# Geotechnical Exploration, Inc.

**Job No. 21-13556**

Subject: **Addendum to the Report of Preliminary Geotechnical Investigation and Geologic Fault Investigation and Response to the City of San Diego Geotechnical Review**  
Proposed Javaheri Residence  
2072 Via Casa Alta  
La Jolla, California

**PLOT PLAN AND SITE SPECIFIC GEOLOGIC MAP**

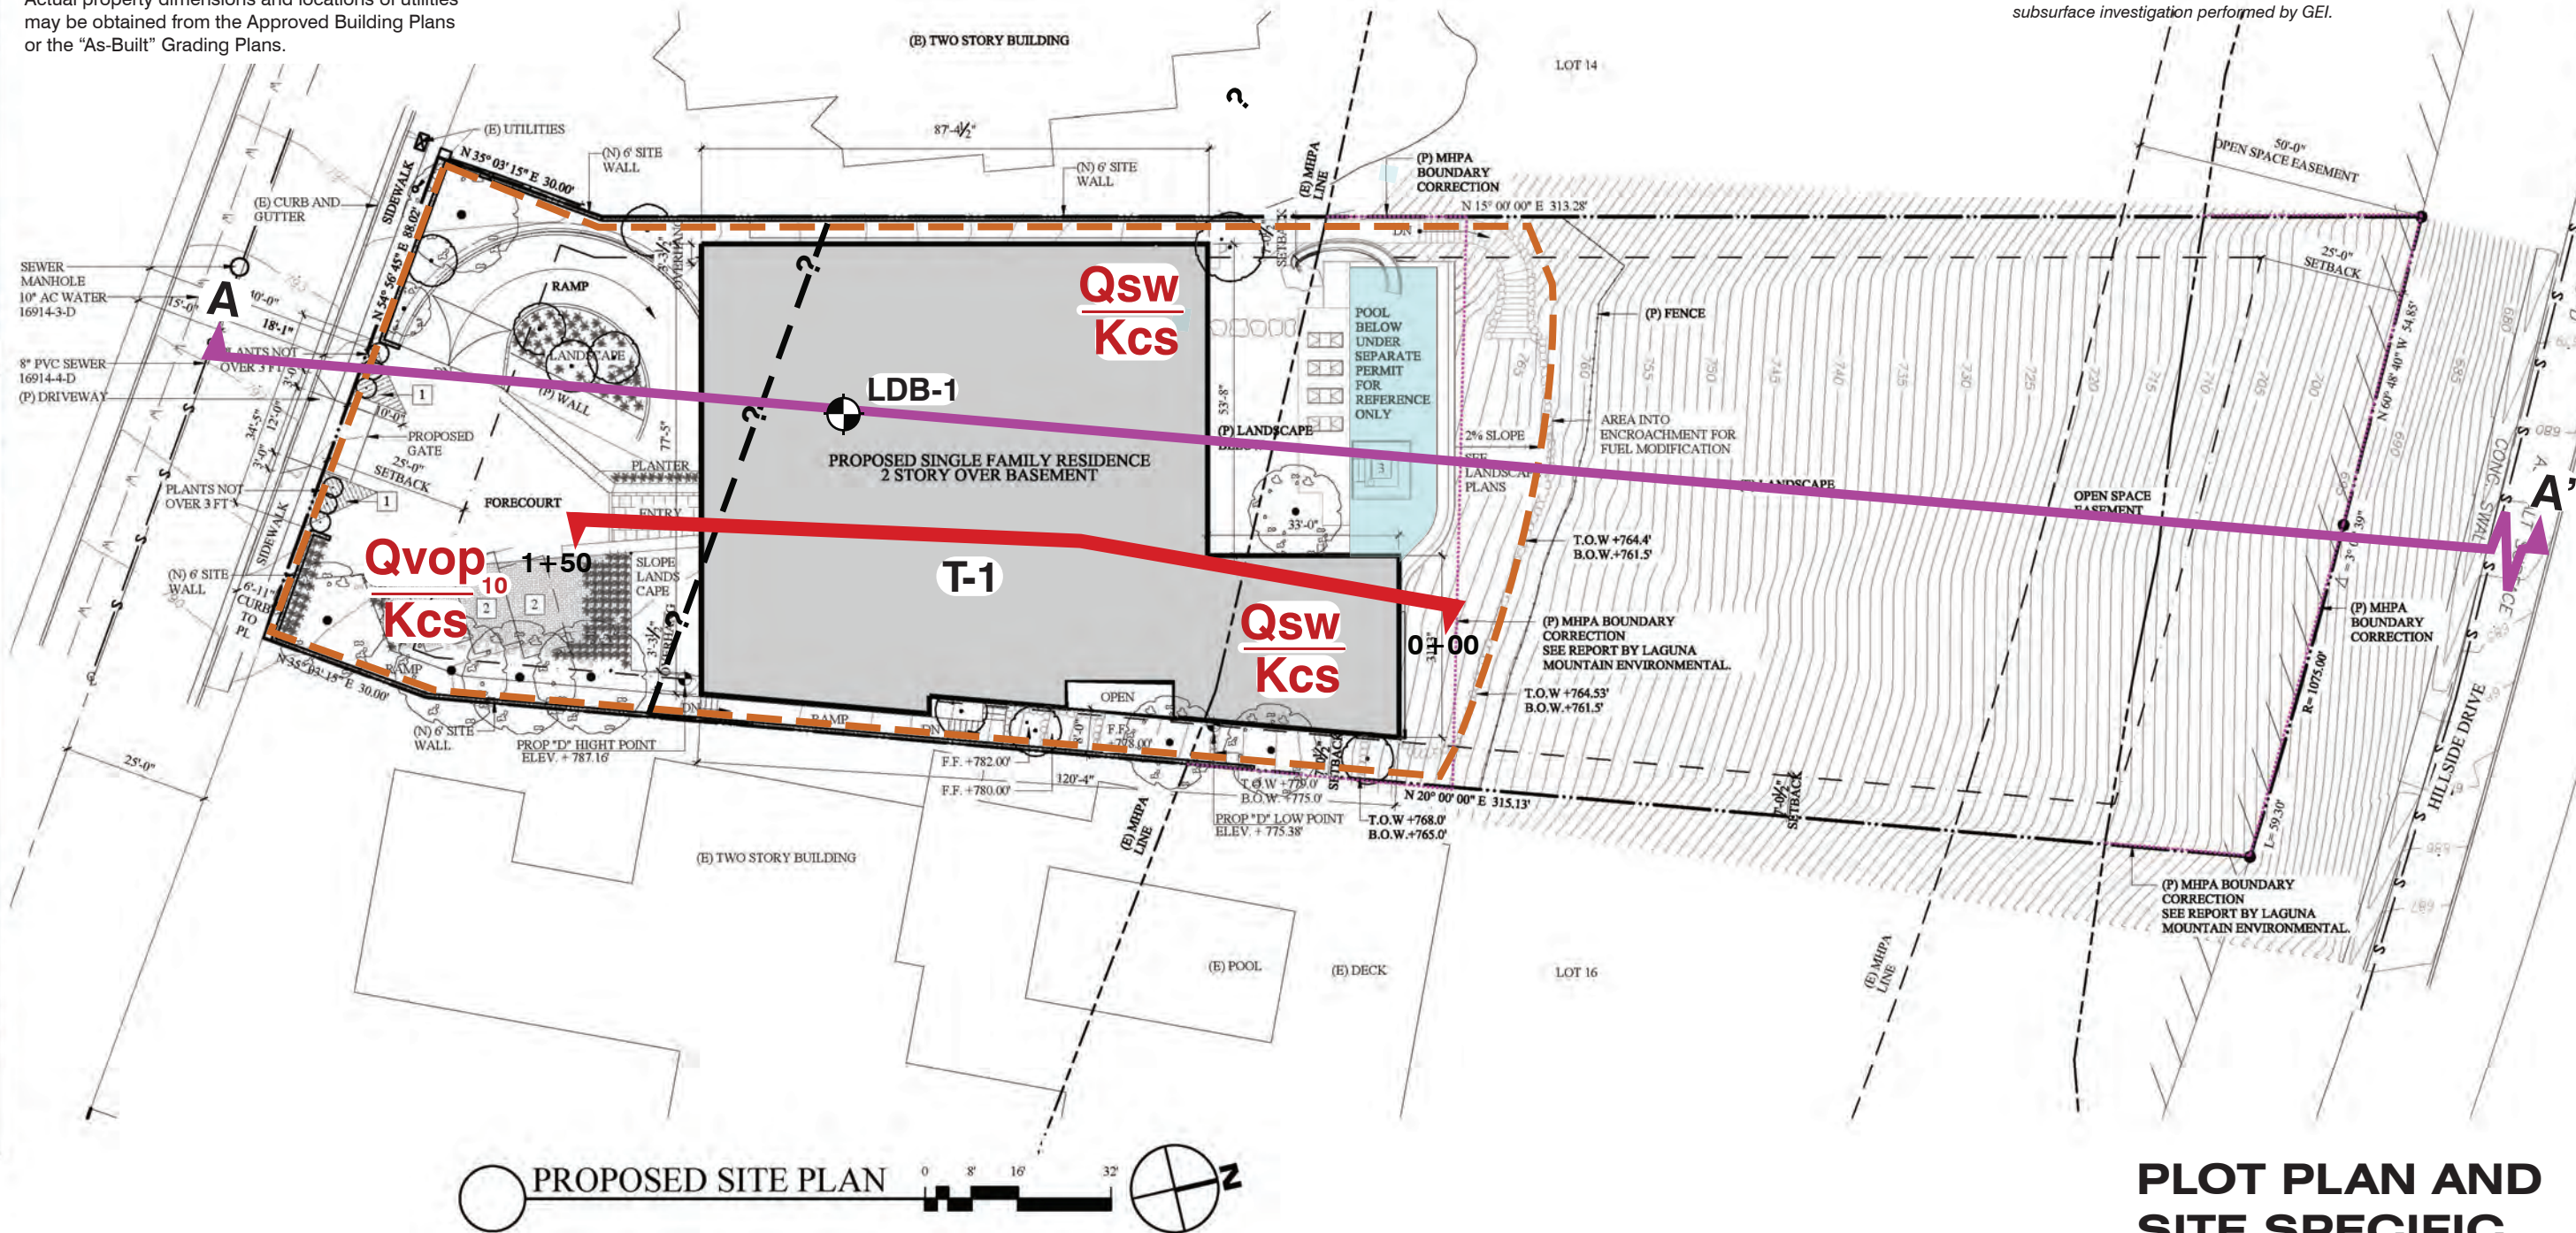
**Issue No. 21:** *Provide an updated geologic/geotechnical map that circumscribes the limits of anticipated remedial grading to delineate the anticipated footprint of the project. (New Issue)*

**Response:** Attached as Figure No. I is an updated geologic/geotechnical map that circumscribes the limits of anticipated remedial grading to delineate the anticipated footprint of the project.

Figure No. II  
Job No. 21-13556

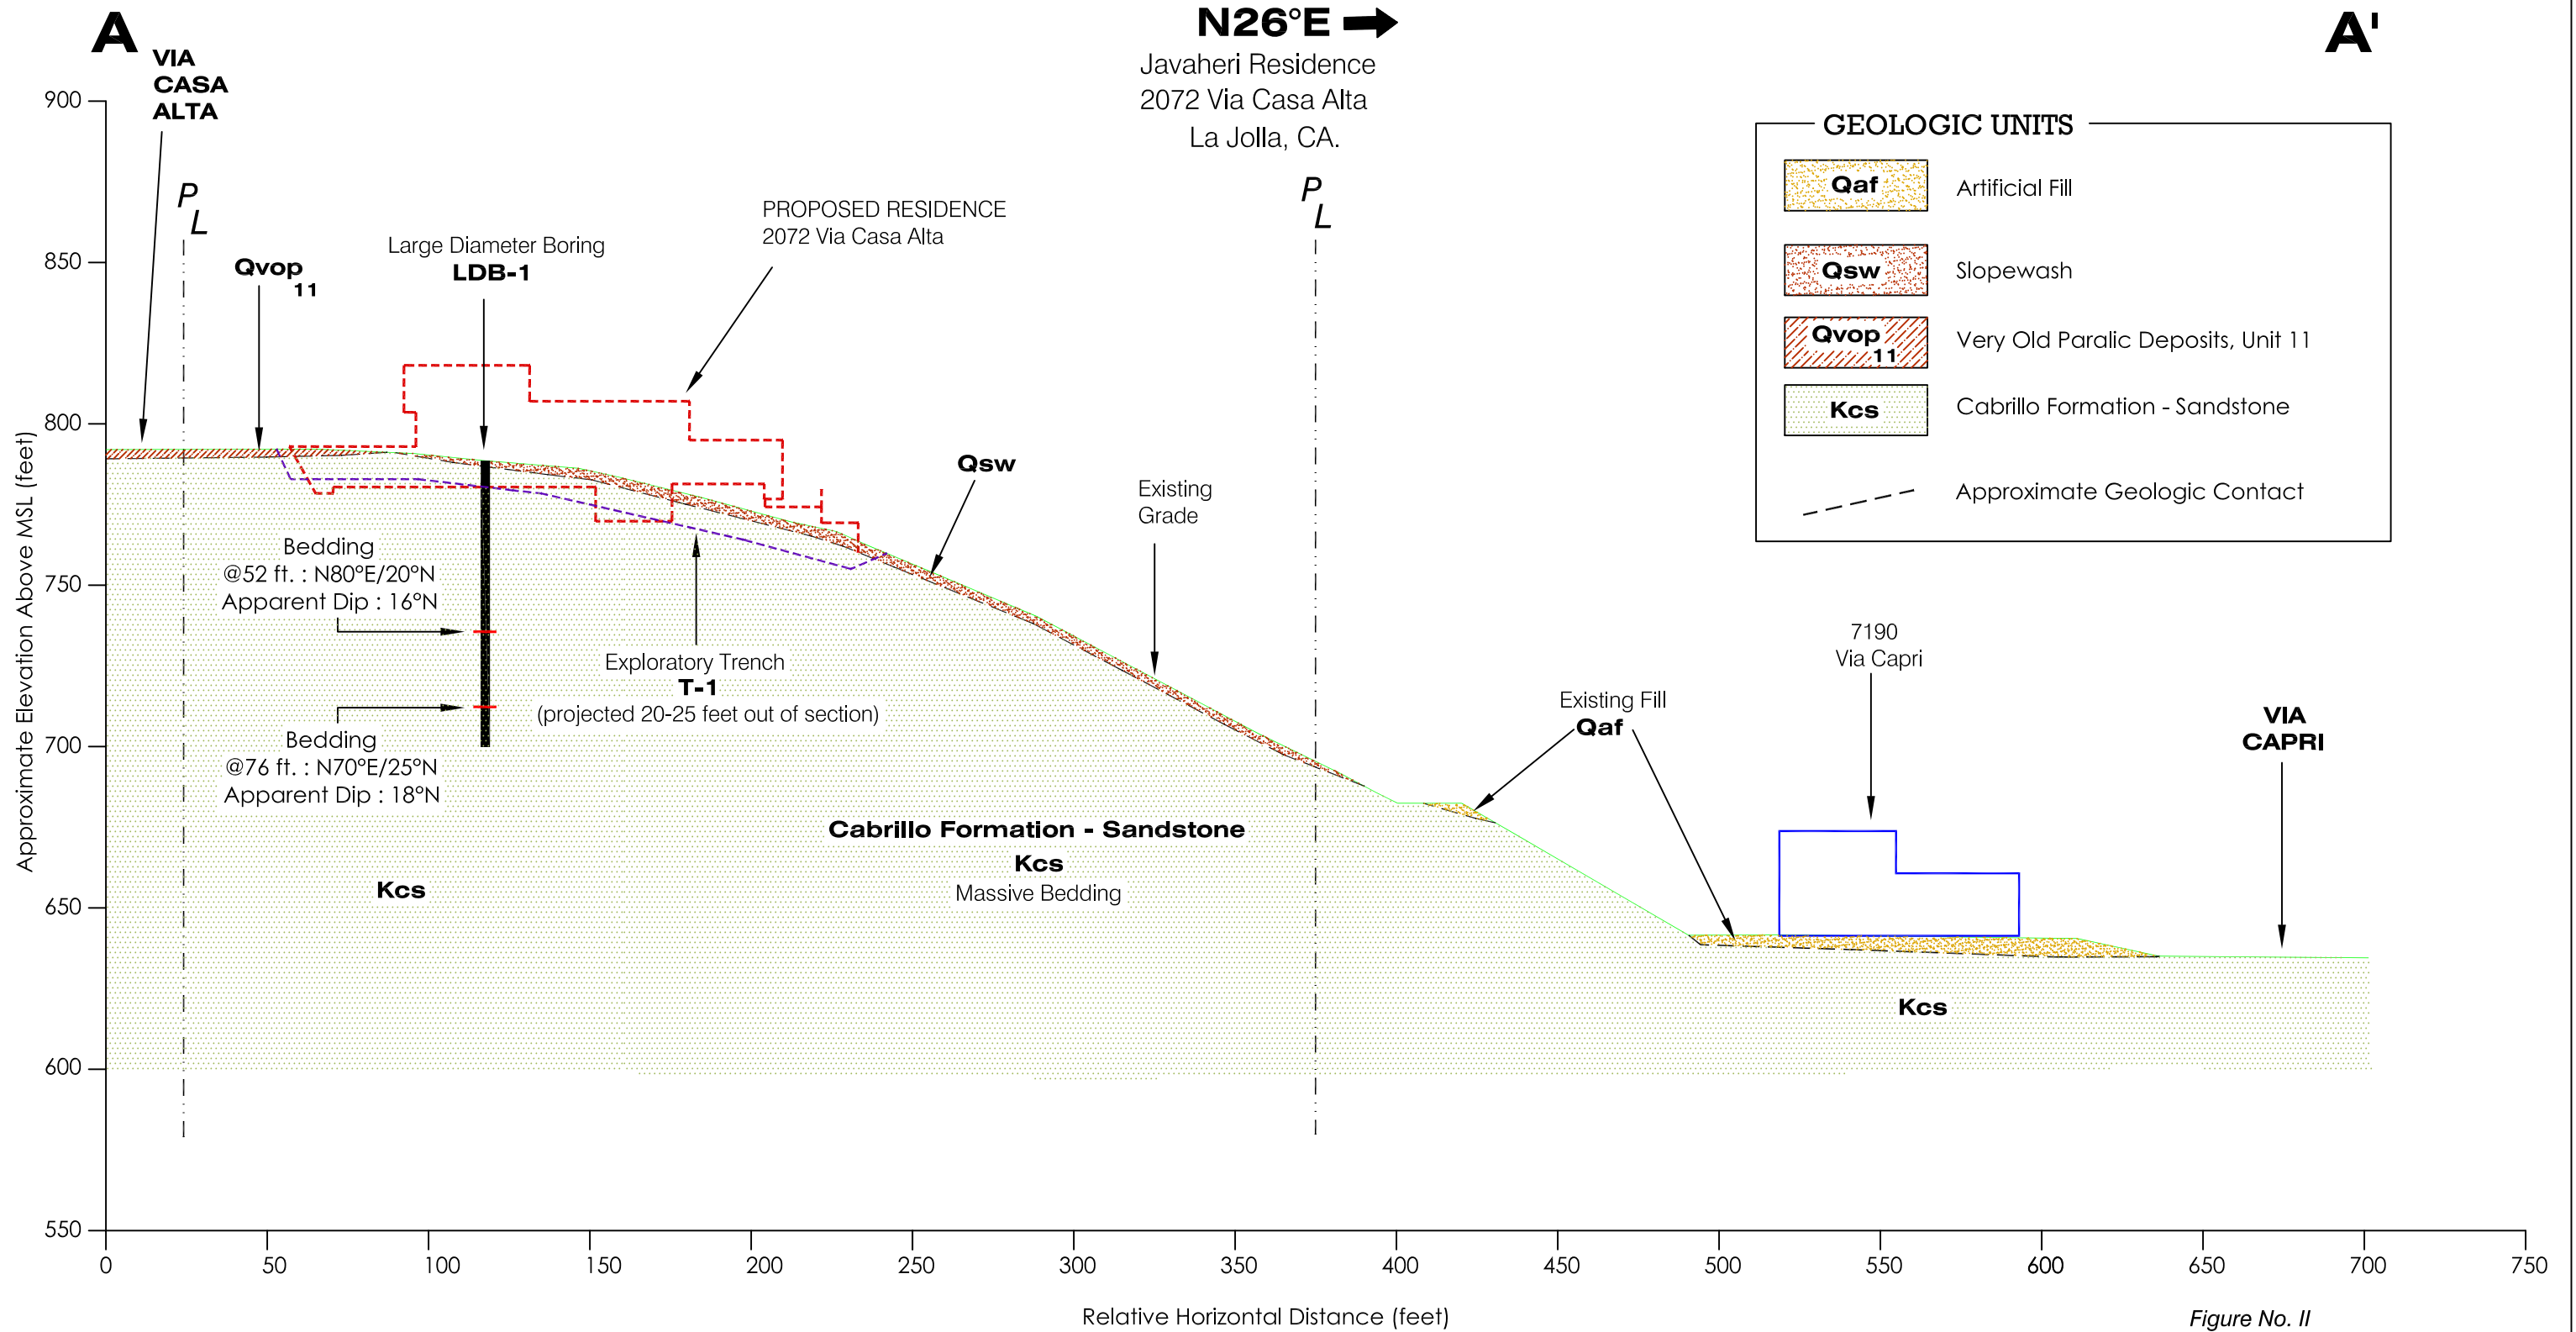
***Issue No. 9:*** *Demonstrate the site will have a factor of safety of 1.5 or greater with respect to gross and surficial slope stability following completion of the project. Provide slope stability analyses consistent with the geologic cross sections. (From Cycle 2)*

**Issue No. 22:** *Provide an updated representative geologic/geotechnical cross section that shows the geologic structure, bedding, and/or apparent dips as documented in the subsurface exploration logs. (New Issue)*

**Response:** We are providing a slope stability analysis based on cross section A-A' through the site. Based on our revised gross and surficial slope stability analysis, the site has a factor of safety of 1.5 or greater and a factor of safety of at least 1.15 in seismic loading analysis. Refer to attached Figure Nos. I and II for the geologic cross section through the site and Appendix A for slope stability analysis.

**Response:** Attached as Figure No. II is an updated representative geologic/geotechnical cross section that shows the geologic structure, bedding, and/or apparent dips as documented in the subsurface exploration logs.

Javaheri Residence  
2072 Via Casa Alta  
La Jolla, CA.  
Figure No. III  
Job No. 21-13556

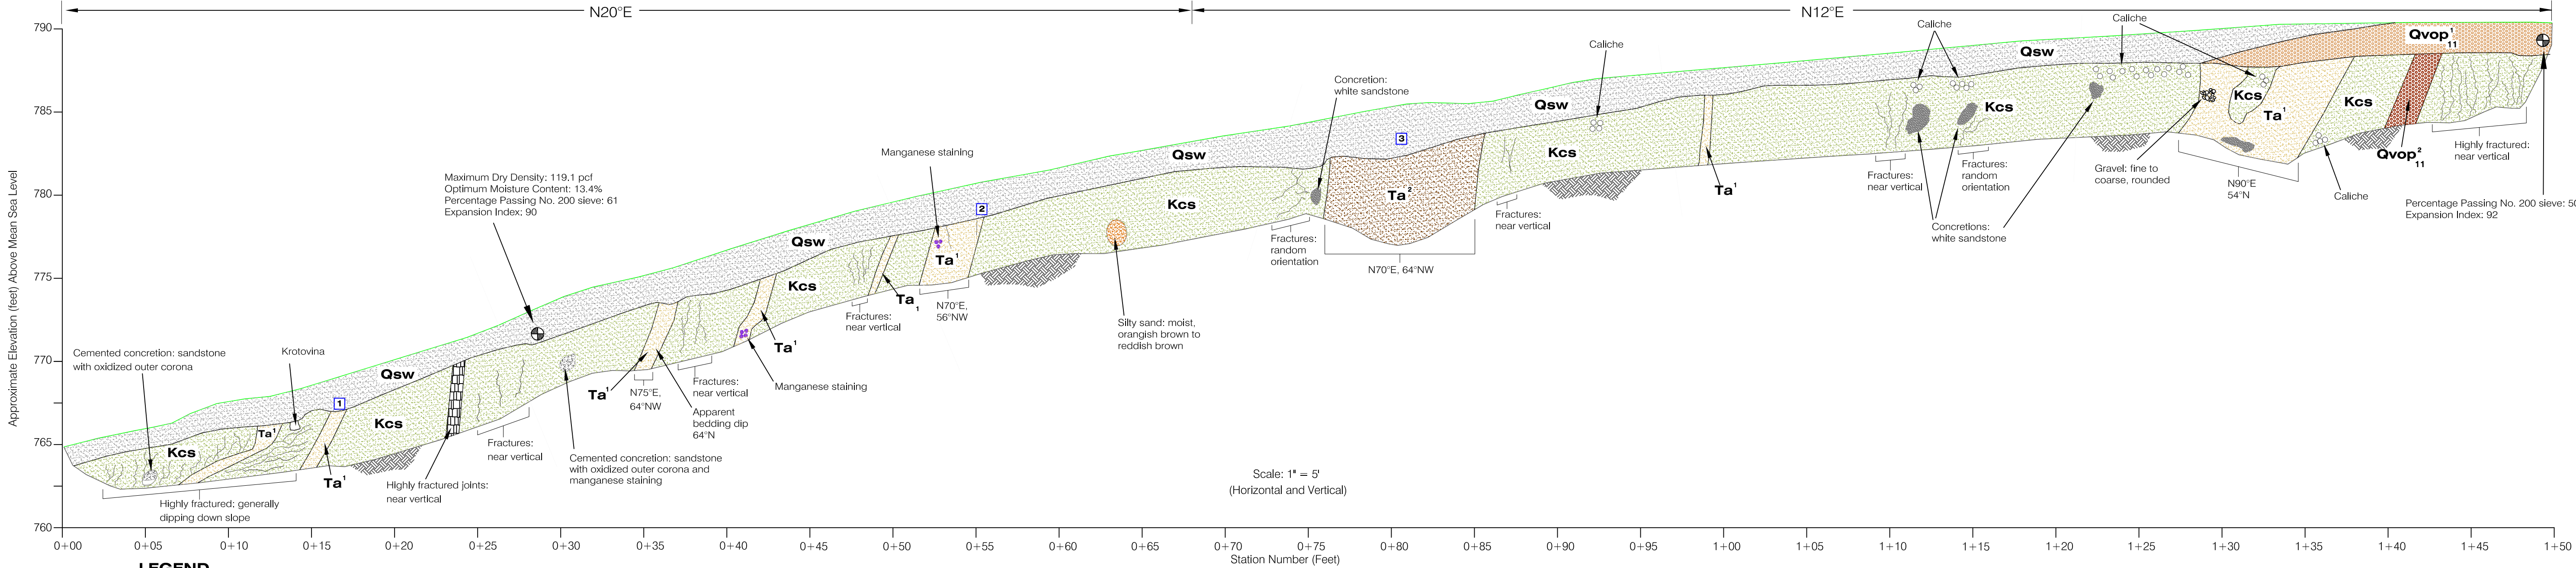
**Issue No. 23:** *Provide a revised Exploratory Trench T-1 log and remove all references to Geologic Cross-Section A-A'. Those references appear to be inaccurate and are confusing. The project's geotechnical consultant could consider simply labeling the trench limits with North and South. (New Issue)*

**Response:** Attached as Figure No. III is a revised Exploratory Trench T-1 log with north and south labeling and no reference to geologic cross section A-A'.
